Access Compliance Report

Public Rights-of-Way

Intersection ID: 14267	Main Street: CLANTON_RD	Cross Street: FARMER_ST	Location: NW
ADA ID: CFD964AE87DE	Ramp Type: Directional1	Initial Pass/Fail: Fail	Overall Compliance: No
		Severity Score: 25

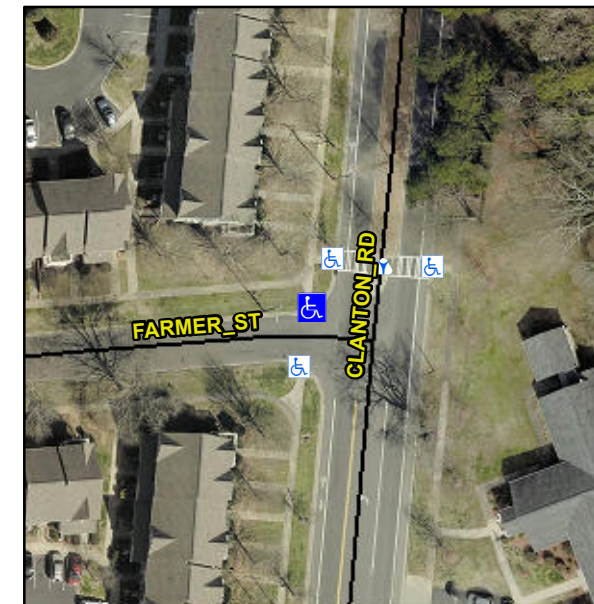
R304.2.2

Compliance	Description	Data	Compliance	Description	Data
N/A	Ramp Length (in)	67.0	N/A	Grade Break?	N/A
Yes	Ramp Width (in)	48.0	N/A	Grade Break Slope (%)	0.0
No	Ramp Slope (%)	17.6	N/A	Grade Break XSlope (%)	0.0
Yes	Ramp XSlope (%)	0.6			
N/A	Flare Type LT	N/A	N/A	Flare Type RT	N/A
N/A	Flare Slope LT (%)	N/A	N/A	Flare Slope RT (%)	0.0
N/A	Flare Traversable LT?	N/A	N/A	Flare Traversable RT?	N/A
N/A	Landing Length (in)	0.0	N/A	DWS Provided?	N/A
N/A	Landing Width (in)	0.0	N/A	DWS Contrast?	N/A
N/A	Landing Slope (%)	0.0	N/A	DWS Length (in)	N/A
N/A	Landing X Slope (%)	0.0	N/A	DWS Full Width?	N/A
N/A	Landing Curb? (Y/N)	N/A	N/A	DWS Offset LT (in)	N/A
N/A	Shared Landing?	N/A	N/A	DWS Offset RT (in)	N/A
N/A	Gutter Ponding?	0.0	N/A	Gutter Slope (%)	N/A
N/A	Gutter Lip Ht (in)	0.0	N/A	Gutter X Slope (%)	N/A
N/A	Painted X Walk1?	No		Road Slope (%)	0.3
	X Walk 1 Direction	To S		Road X Slope (%)	5.1
	X Walk 1 Width (in)	N/A		Clear Space?	N/A

Remove & Replace Entire Ramp.
